# Seattle Public Utilities (SPU) Madison Valley Long-Term Stormwater Project SEPA ADDENDUM May 26, 2009

# **Proposed Pipeline Alignments**

**Figure 1. Proposed Pipeline Alignments**

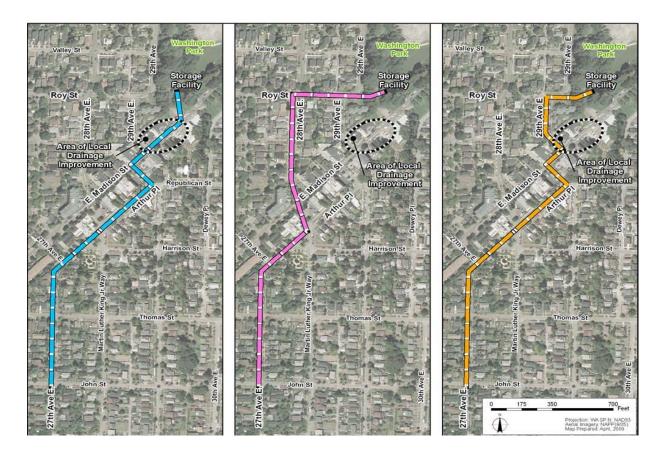
SPU is now refining the design for Phase 2B and is considering a modification to a portion of the conveyance pipeline alignment. Two alternative routes are being considered, referred to in Figure 1 as Alternative 2B-1 and 2B-2. Alternative 2B-1 begins at 27<sup>th</sup> Avenue East and East John Street, heads north along 27<sup>th</sup> Avenue East to East Arthur Place, then turns northeast along East Arthur Place to Martin Luther King Jr. Way East, then turns north along Martin Luther King Jr. East and, where Martin Luther King Jr. Way East turns into 28<sup>th</sup> Avenue East, continues north on 28<sup>th</sup> Avenue East to East Roy Street, and last turns east along East Roy Street continuing east to a new stormwater storage facility at Washington Park. The total distance for Alternative 2B-1 is approximately 2,425 feet.

Alternative 2B-2 also begins at 27<sup>th</sup> Avenue East and East John Street, heads north along 27<sup>th</sup> Avenue East to East Arthur Place, then turns northeast along East Arthur Place to 29<sup>th</sup> Avenue East, then turns north along 29<sup>th</sup> Avenue East to East Madison Street, then turns northwest along 29<sup>th</sup> Avenue East to East Madison Street, then turns northeast along East Madison Street to 29<sup>th</sup> Avenue East, then turns northwest and north along 29<sup>th</sup> Avenue East to East Roy Street, and last turns east on East Roy Street continuing east to a new stormwater storage facility at Washington Park. The total distance for Alternative 2B-2 is approximately 2,225 feet.

Additionally, SPU is considering an alternative method of trenchless technology to minimize construction impacts along the pipeline alignment for Alternative 2B-1. The total volume of vehicular trips would be reduced to approximately 1,250 trips for trenchless methods compared to approximately 3,400 trips for open cut construction methods proposed for Alternative 2B-2. Approximately 3,500 trips were estimated initially for the Phase 2B baseline alignment.

Greenhouse Gas(GHG) Emissions totals also would be reduced to approximately 996 MTCO2e for trenchless methods (Alternative 2B-1) compared to approximately 1,896 MTCO2e for open cut methods (Alternative 2B-2)

due to substantial reduction in the number of construction trips and in the amount of pavement replaced. Table 1 summarizes the differences between the three proposed pipeline alignment routes.
